ATTACHMENT TO LICENSE AMENDMENT NO. 61

PROVISIONAL OPERATING LICENSE NO. DPR-18

DOCKET NO. 50-244

Revise Appendix A Technical Specifications by removing the pages identified below and inserting the enclosed pages. The revised pages contain the captioned amendment number and marginal lines which indicate the area of changes.

FIGURE 2.1-1  
 CORE DNB SAFETY LIMITS  
 2 LOOP OPERATION

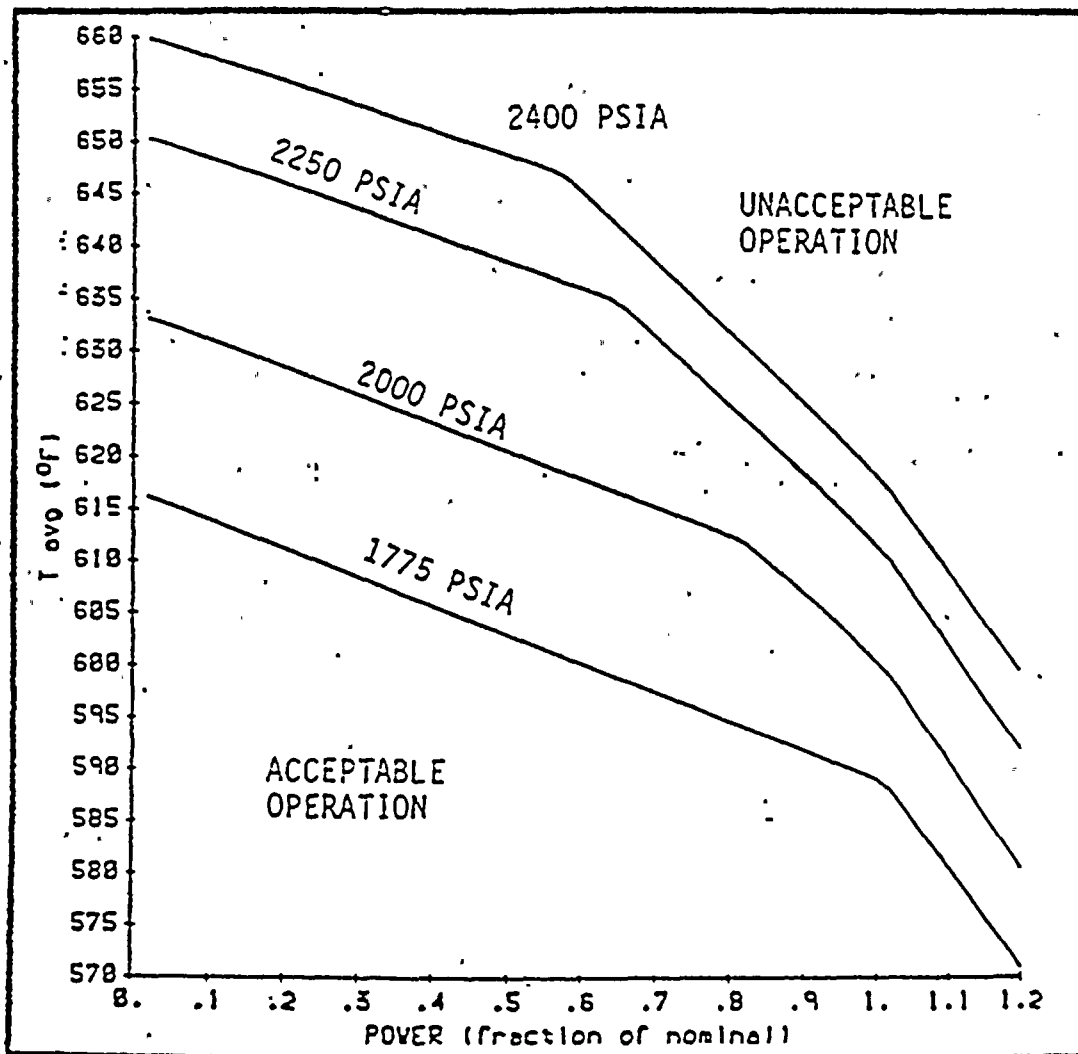
The curves of Figure 2.1-1 represent the loci of points of thermal power, coolant system pressure and average temperature for which this minimum DNB value is satisfied. The area of safe operation is below these lines.

Since it is possible to have somewhat greater enthalpy rise hot channel factors at part power than at full power due to the deeper control bank insertion which is permitted at part power, a conservative allowance has been made in obtaining the curves in Figure 2.1-1 for an increase in  $F_{\Delta}^N H$  with decreasing power levels. Rod withdrawal block and load runback occurs before reactor trip set points are reached.

FIGURE 3.10-3

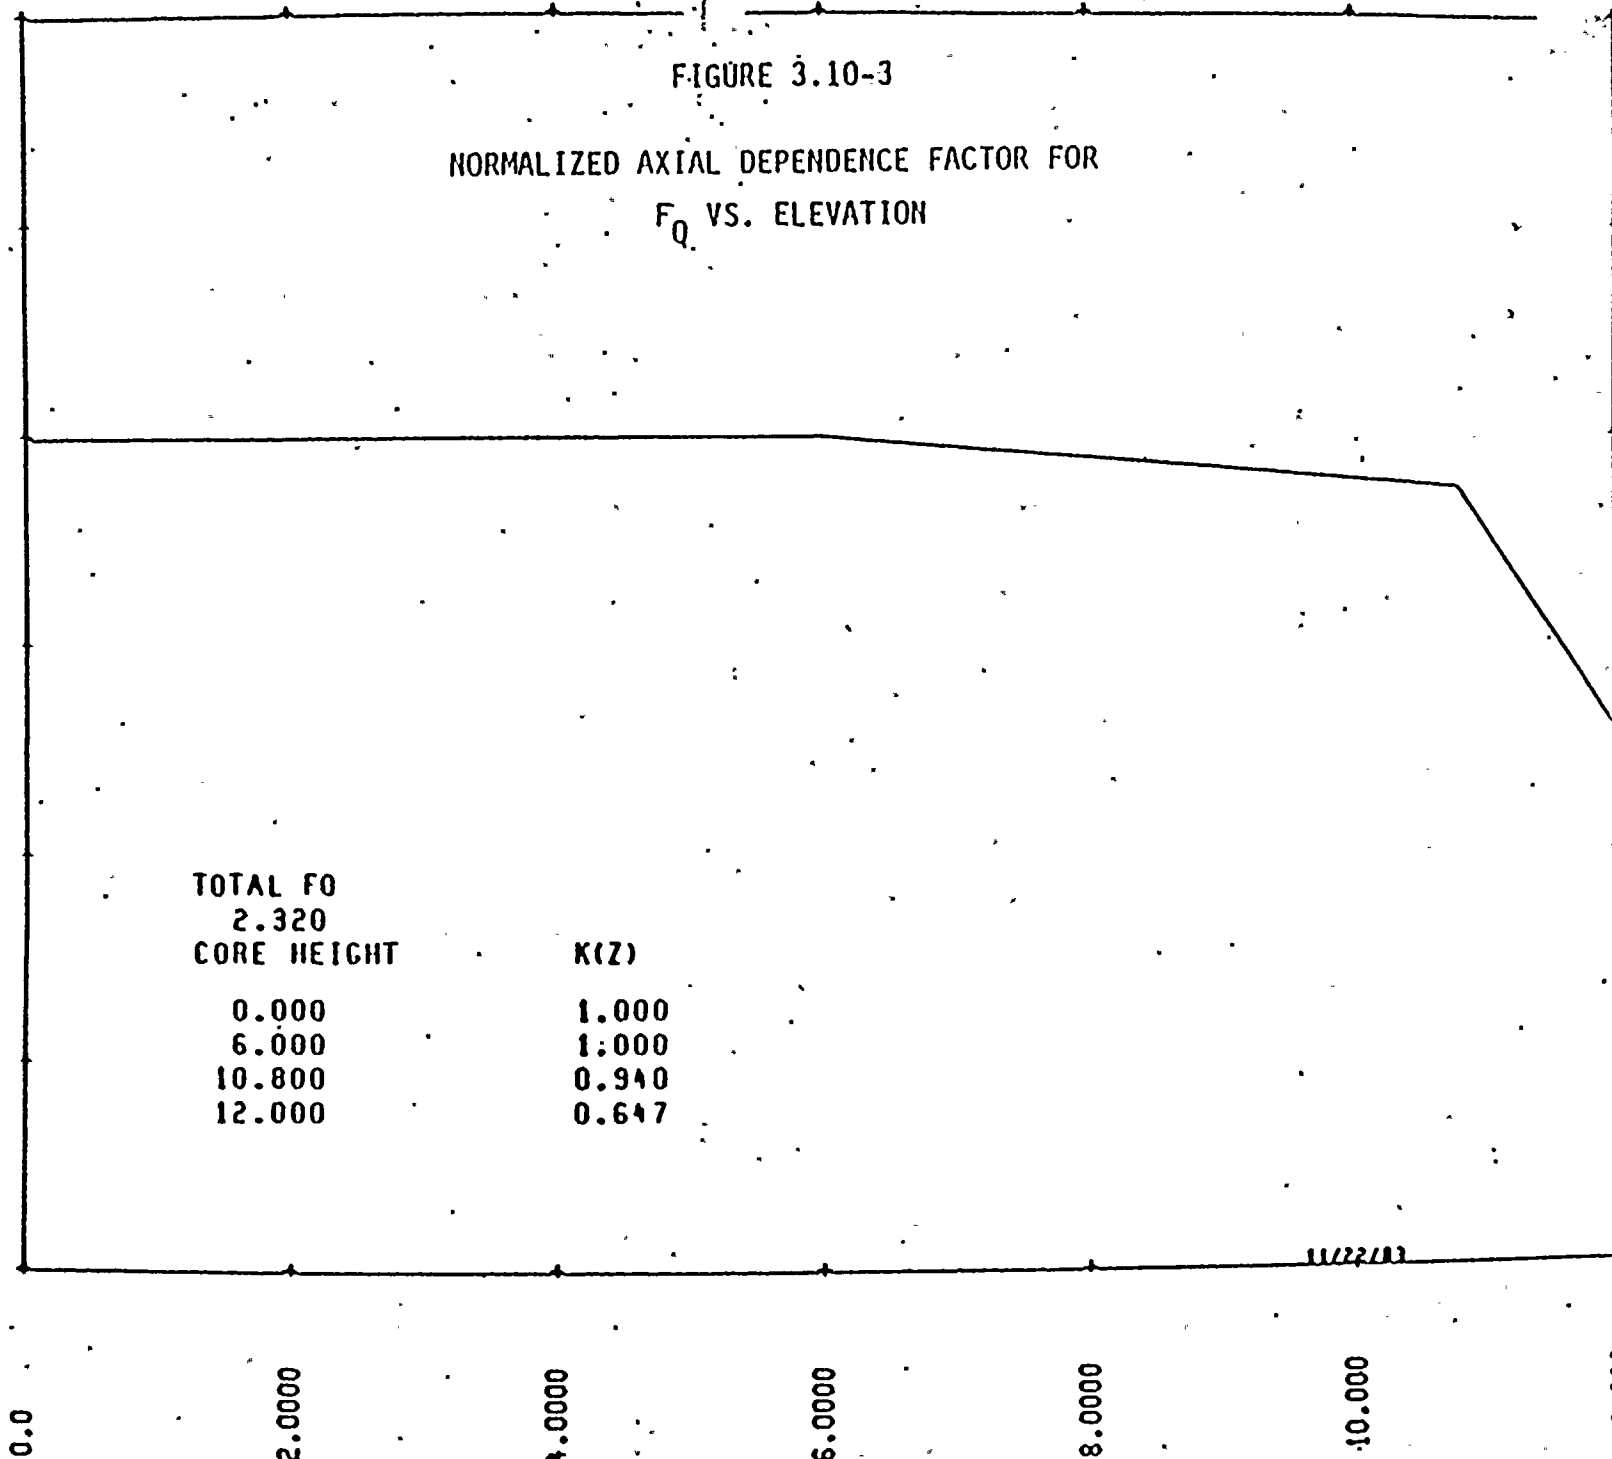
where P is the fraction of rated power at which the core is operating, K(Z) is the function given by Figure 3.10-3, and Z is the height in the core. The measured  $F_Q^N$  shall be increased by three percent to yield  $F_Q$ . If the measured  $F_Q$  or  $F_{\Delta H}^N$  exceeds the limiting value, with due allowance for measurement error, the maximum allowable reactor power level and the Nuclear Overpower Trip set point shall be reduced on percent for each percent which  $F_{\Delta H}^N$  or  $F_Q$  exceeds the limiting value, whichever is more restrictive. If the hot channel factors cannot be reduced below the limiting values within one day, the Overpower  $\Delta T$  trip setpoint and the Overtemperature  $\Delta T$  trip setpoint shall be similarly reduced.

$$F_Q(Z) = (2.32/P)*K(Z) \quad \text{for } P \geq .5$$

$$F_Q(Z) = 4.64*K(Z) \quad \text{for } P \leq .5$$
